# PLANNING COMMISSION MEETING

LOCATION: TOWNSHIP ANNEX, 7527 HIGHLAND ROAD, WHITE LAKE, MICHIGAN, 48383 (FORMER WHITE LAKE LIBRARY)
THURSDAY, JUNE 16, 2022 – 7:00 PM

- 1. CALL TO ORDER
- 2. ROLL CALL
- 3. PLEDGE OF ALLEGIANCE
- 4. APPROVAL OF AGENDA
- 5. APPROVAL OF MINUTES
  - A. Minutes of May 19, 2022
- 6. CALL TO THE PUBLIC (FOR ITEMS NOT ON THE AGENDA)
- 7. PUBLIC HEARING
  - A. Elizabeth Lake Retail

White Lake Plaza- Preliminary Site Plan Review - 8th Review RE:

TRASH
ENCLOSURE
DETAILS

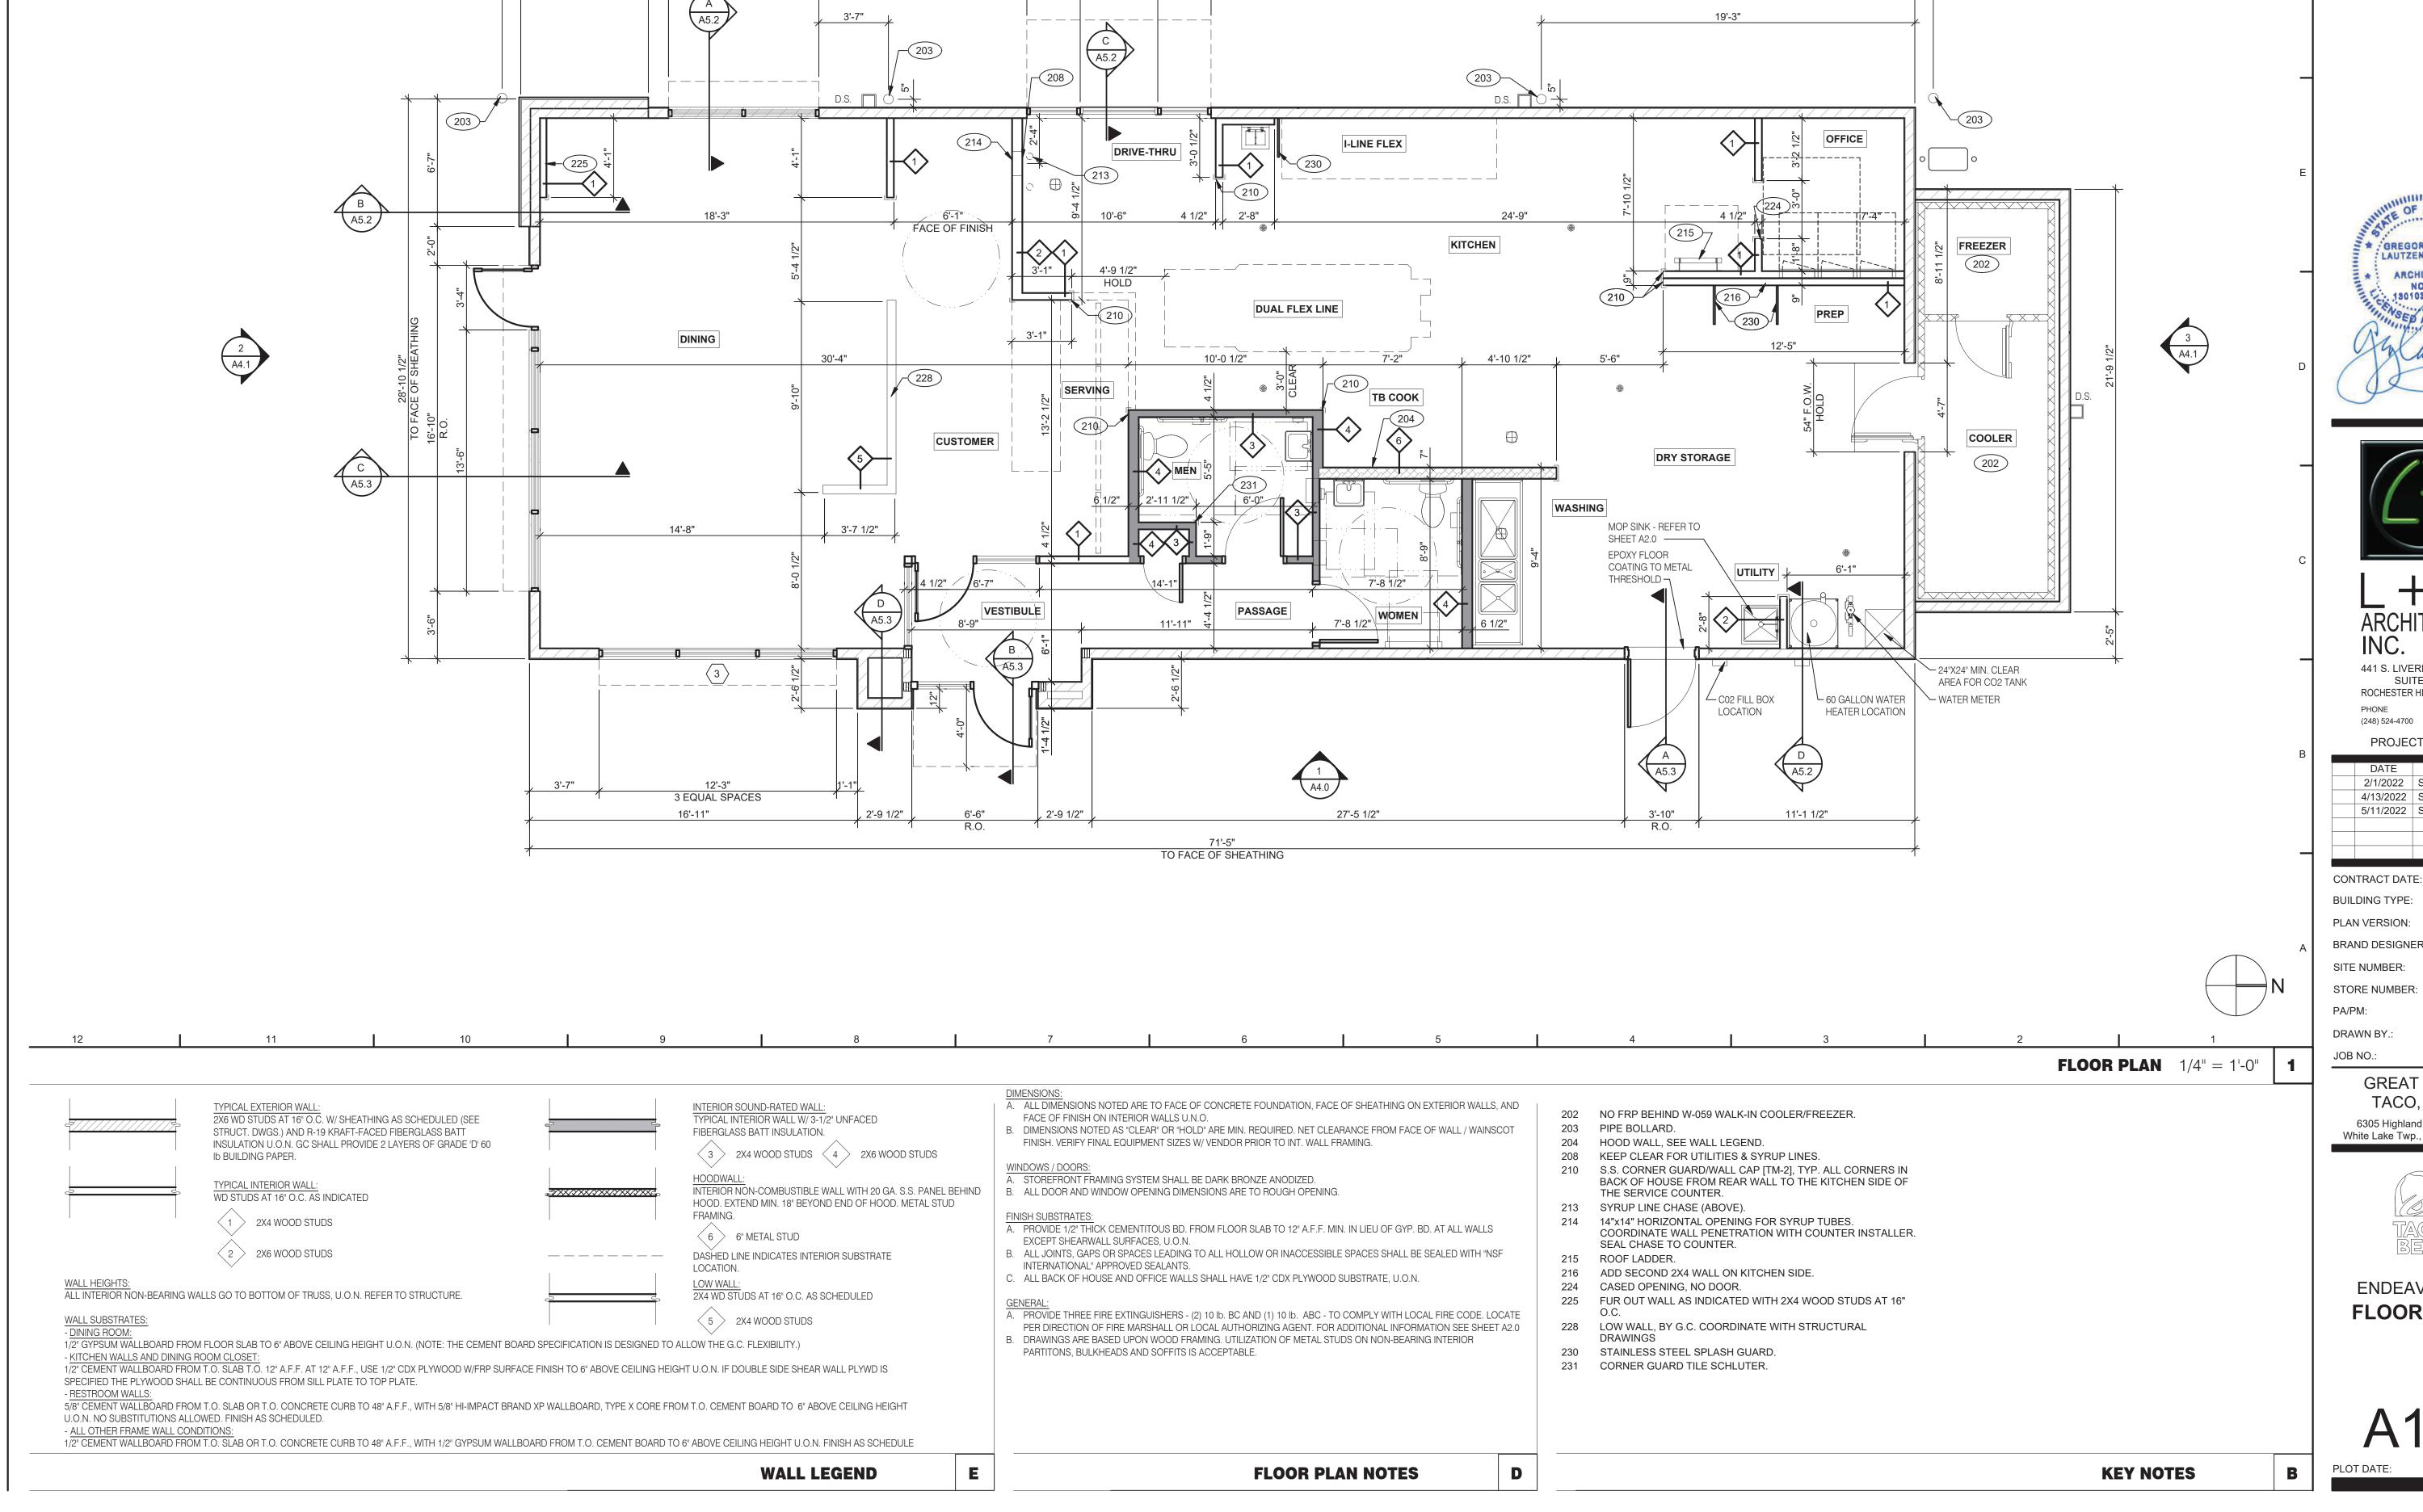
- The trash enclosure detail (Sheet G2.0) shall be revised to indicate which brick veneer (multiple proposed) would cover the exterior face of the dumpster/trash storage enclosure. Staff recommends utilizing accent #1 brick veneer to cover the exterior face of the dumpster/trash storage enclosure.

- The Applicant shall clarify the purpose of the 200-gallon outdoor grease container within the dumpster/trash storage enclosure. DLZ informed staff such grease containers are typically used for disposal of fryer grease and get emptied by a waste collection company when full. Per the Engineering Design Standards and sanitary sewers ordinance, all leads to commercial or institutional food service operations shall have a 1,000-gallon grease interceptor (proposed see Sheet C5.0). Two, 96-gallon compost bins are also proposed within the dumpster/trash storage enclosure. Staff is concerned the outdoor grease container and compost bins could become a nuisance if not maintained. Also, a spill could occur during transfer of fats, oils, and grease (FOG) from inside the building to the outdoor storage container. If not necessary for the operation of the restaurant, consideration should be given to eliminating said bins and container; this would allow the dumpster/trash storage enclosure to be reduced in size.
